FRANCIA AND GARDNER SUBDIVISION

APPLICATION NUMBER 2 DATE February 20, 2020

REQUEST Subdivision

DETAIL SITE PLAN

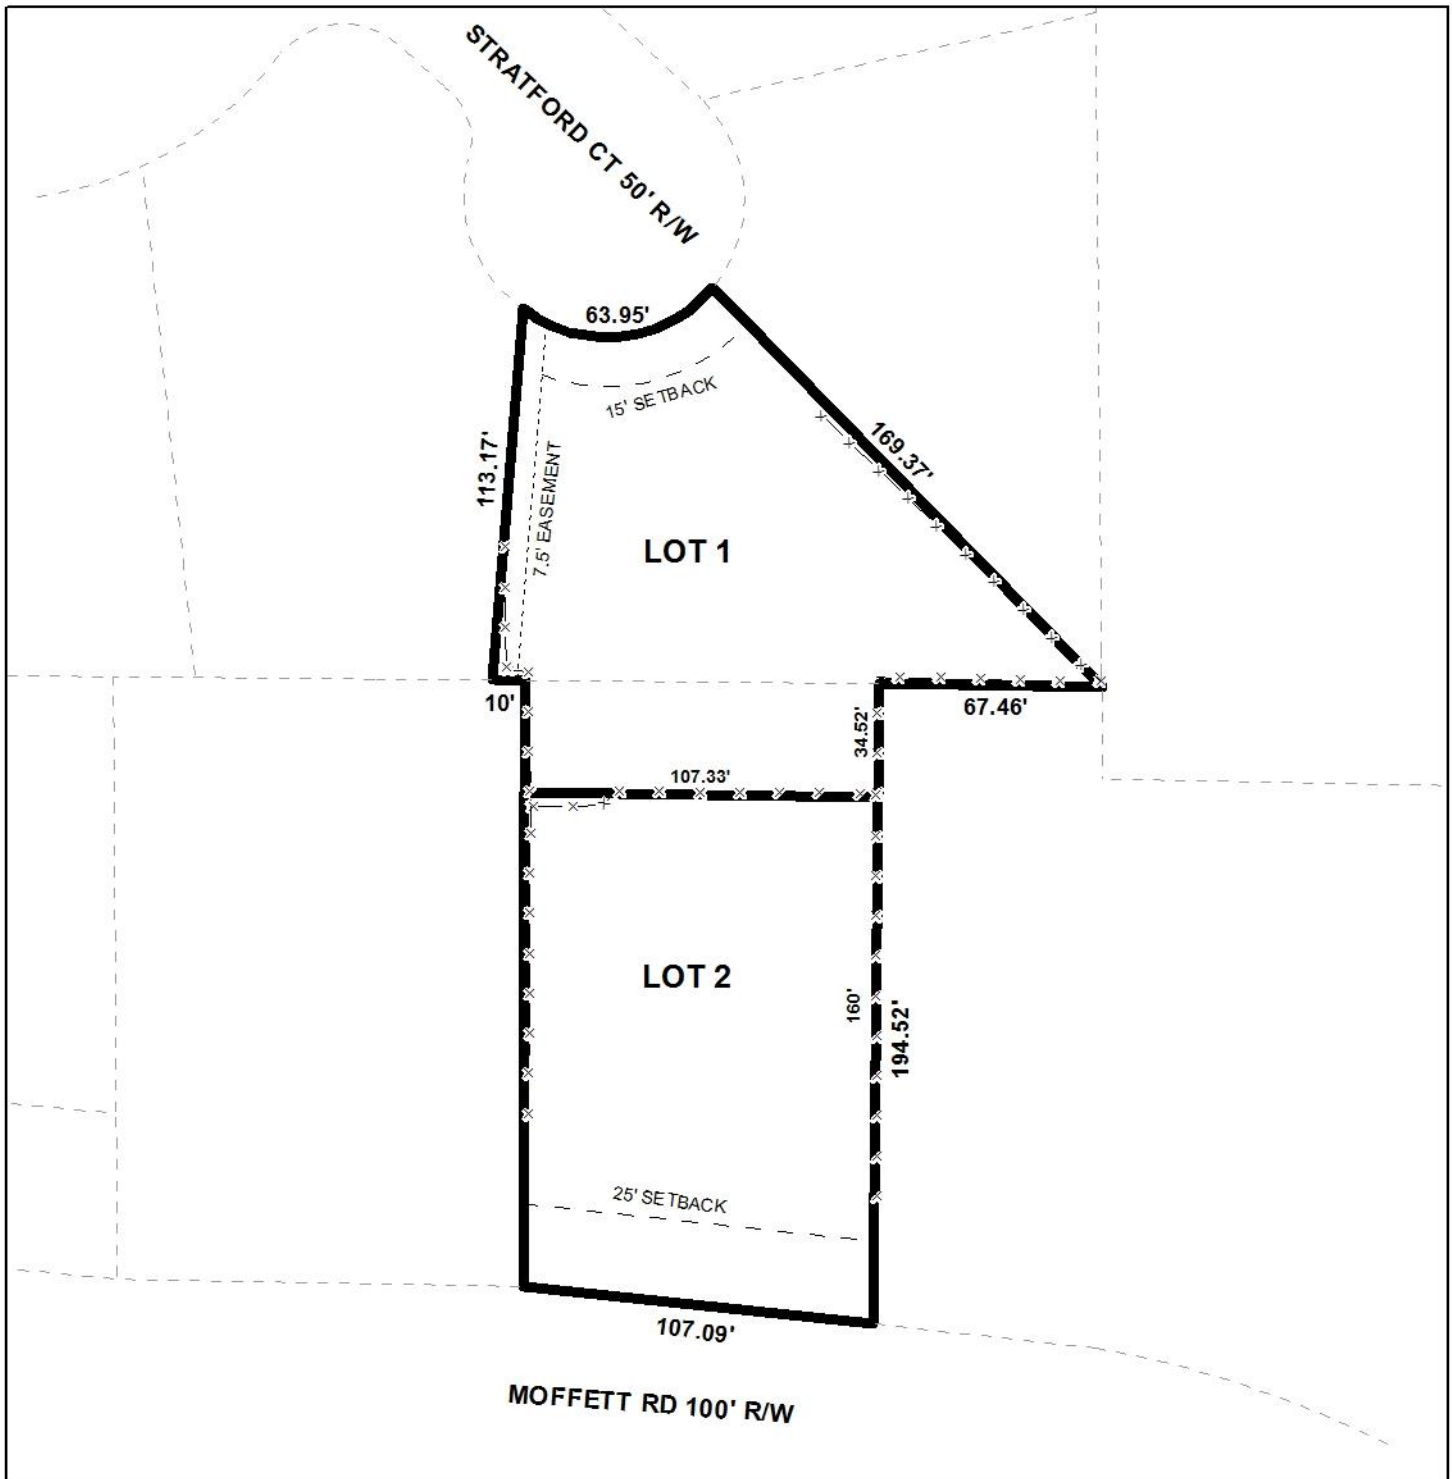
In accordance with the Subdivision Regulations, both proposed lots exceed the minimum size requirements. If approved, the lot size labels in square feet and acres should be retained on the Final Plat or a table should be furnished on the Final Plat providing the same information.

The proposed Lot 1 fronts Stratford Court which is a minor street with curb and gutter. As such, the preliminary plat illustrates a compliant 50 foot right-of-way and should be retained on the Final Plat. Lot 2 fronts Moffett Road, a major street according to the Major Street Plan component of the Comprehensive Plan, with a compliant 100 foot right-of-way.

Per a 1963 plat recorded with Mobile County Probate, the minimum front yard setback for the proposed Lot 1 is 15 feet; however, the Zoning Ordinance and Subdivision Regulations require a minimum 25 foot front setback. As such, if approved, the Final Plat should be revised to illustrate a 25 foot minimum building setback line for Lot 1. The preliminary plat illustrates a 25 foot minimum building setback line for Lot 2 and should be retained on the Final Plat. As a means of access management, a note containing the Traffic Engineering comments should be placed on the Final Plat.

Additionally, as easements are recorded on the subject property they should be indicated and labeled on the Final Plat, and a note should be placed on the Final Plat stating that no structure may be placed or constructed within any easement.

- 1) retention of the lot size labels in both square feet and acres on the Final Plat or the furnishing of a table on the Final Plat providing the same information;

- 2) revision to illustrate a 25 foot minimum building setback along Stratford Court on the Final Plat;
- 3) retention of the 25 foot minimum building setback along Moffett Road on the Final Plat;

- 4) retention of the 50 foot right-of-way for Stratford Court on the Final Plat;
- 5) retention of the 100 foot right-of-way for Moffett Road on the Final Plat;

- 6) retention of the easements on the Final Plat;
- 7) placement of a note on the Final Plat stating that no structure may be placed or constructed within any easement;
